**Summary:** The Tentative Decision was distributed for public review between August 19, 2022 and November 7, 2022. The City received a comment letter from the City Engineer. No other letters were received. The City Engineer felt that additional conditions of approval were needed to assure compliance with development code criteria and requirements. All recommended conditions of approval were added. One duplicate condition of approval was deleted. The conditions of approval and analysis below have been revised to reflect the input provided from the comment. All revised conditions and analysis are shown in italics.

**Proposal:** The application proposes to divide 2.48 acres into 2 parcels, parcel 1 is proposed to be 95,983 square feet with an existing single-family residence and parcel 2 is vacant and proposed to be 12,957 square feet on NE Millersburg Drive.

TENTATIVE PARTITION PLAT  
 FOR  
**TRAVIS TOWNSEND**  
 LOCATED IN  
 TAX LOT 352, MAP 105-3W-17  
 SW 1/4 SEC. 17, T. 10 S., R. 03 W., W.M.  
 IN THE  
 CITY OF MILLERSBURG, LINN COUNTY, OREGON

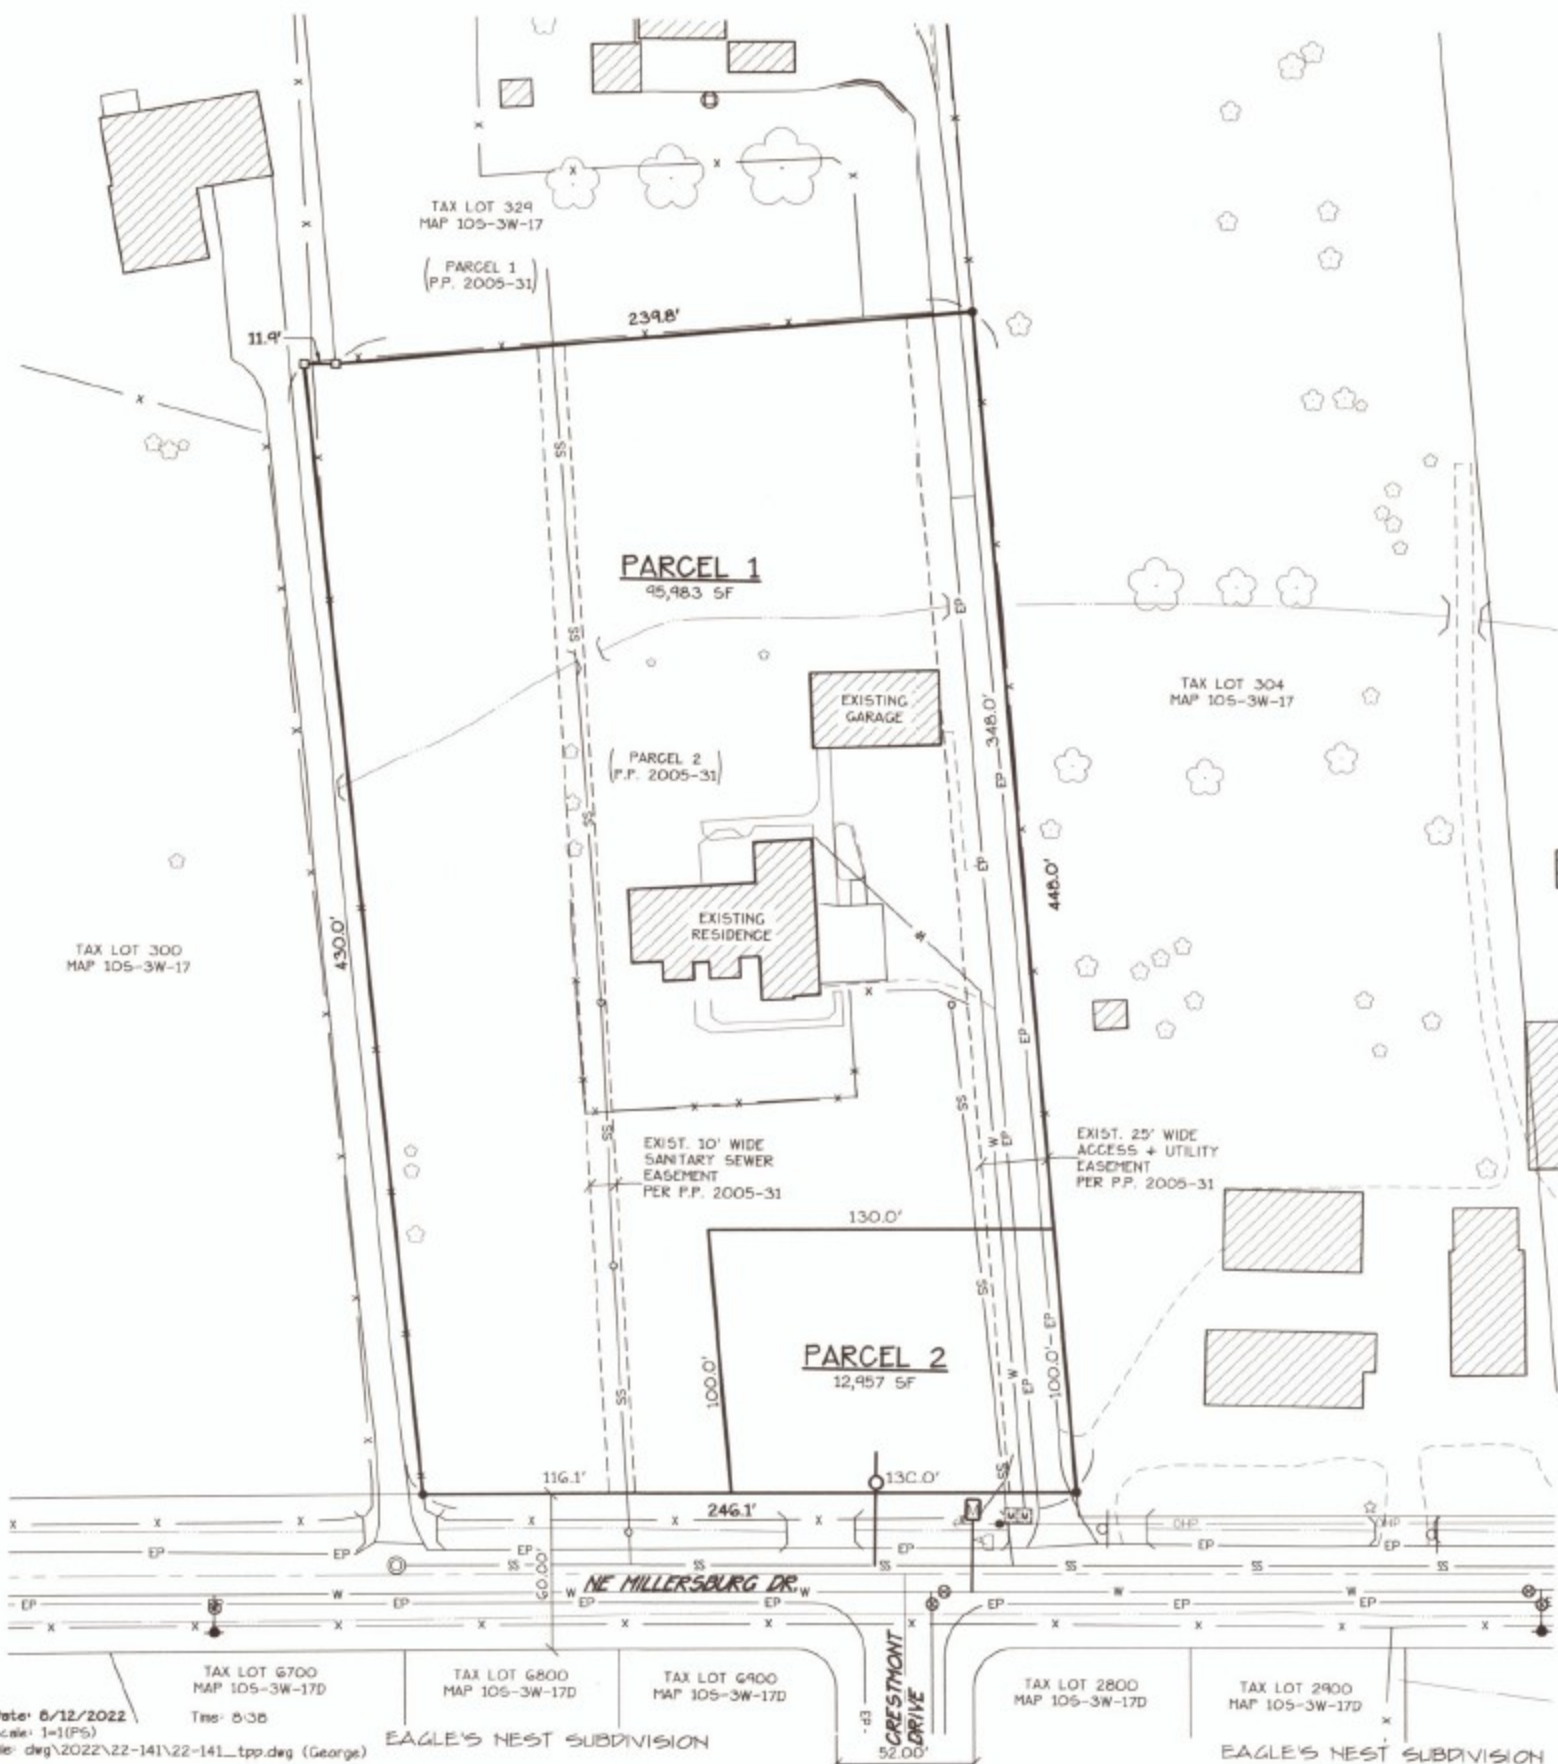
Lastly, subsection (4) requires a fire turnaround for any access easement longer than 150 feet. The existing access easement is over 448 feet. No turnaround exists or is provided. The applicants existing home on the property has a driveway that could function as a turnaround, but is not currently part of the easement. A condition of approval has been added to have the applicant either add a fire turnaround to existing easement (and construct the turnaround) or expand the easement to include the existing driveway on the existing home. This must include no parking however within the turnaround. Either way, the turnaround must be shown on the final plat and constructed prior to the map recording.

**ANALYSIS:** This section explains that the minimum lot size must be able to meet the zoning requirements apart from the easement. The project meets this requirement, as the new parcel is over 12,000 square feet and more than 10,000 outside the easement. This section also notes that the house setback must be taken from the easement, not the property line. This has been added as a condition of approval.

**ANALYSIS:** The applicant did not provide details regarding drainage. A drainage plan will need to be submitted.

- Prior to the City approval of the Final Plat, a fire turnaround must be shown that meets the standards of Albany Fire and the Millersburg City Development Code.
- Prior to the recording of the final plat, all fire turnarounds must be constructed and meet the specifications of Albany Fire and the Millersburg City Development code. No parking signs shall be placed within the fire turnaround.

- All applicable setbacks for the eventual home built on Parcel 2 must be taken from the easement, not the property line.

- Prior to City approval of the final plat, the applicant shall submit for approval a drainage plan that meets all the requirements of the Millersburg Development Code Chapter 3.04, to the satisfaction of the City Engineer.
- Prior to City approval of the final plat, the applicant shall construct all required drainage facilities, or provide bonding (or similar) for all improvements approved by the City.
